Sunfield Fast-track

Auckland Council Specialist Memo

Noise and vibration

Noise and Vibration Memo

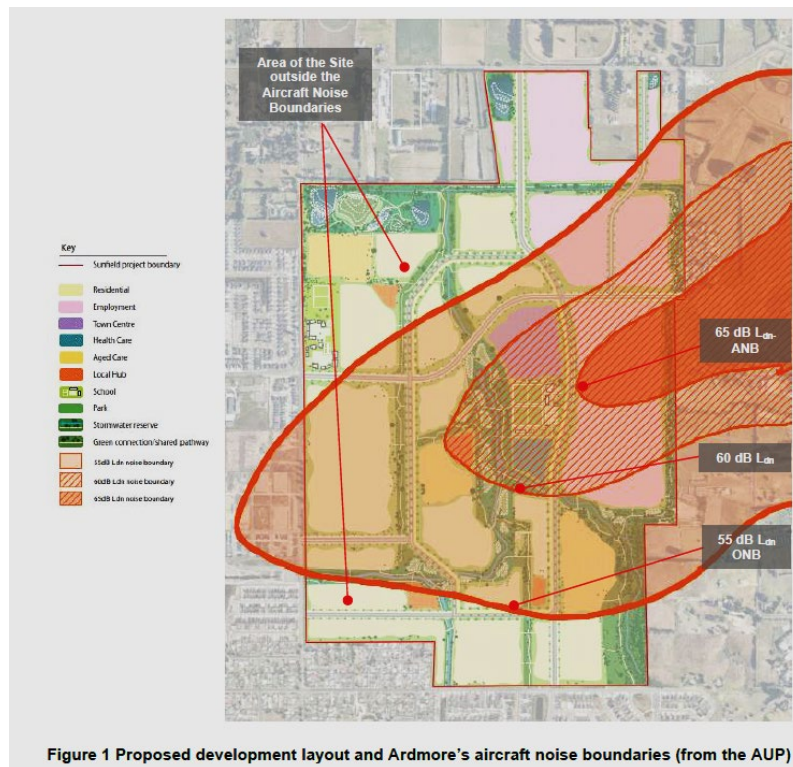
7. The proposal comprises a large-scale community development covering 244 hectares.
8. I confirm Figure 1 (reproduced below) correctly shows the location of the projected noise contours as shown on Council's GEOMAPS. Styles Group have marked up the contours to identify the 65 dB L_{dn} contour (or Air Noise Boundary), 60 dB L_{dn} contour and 55 dB L_{dn} contour (or Outer Noise Boundary) related to the site.
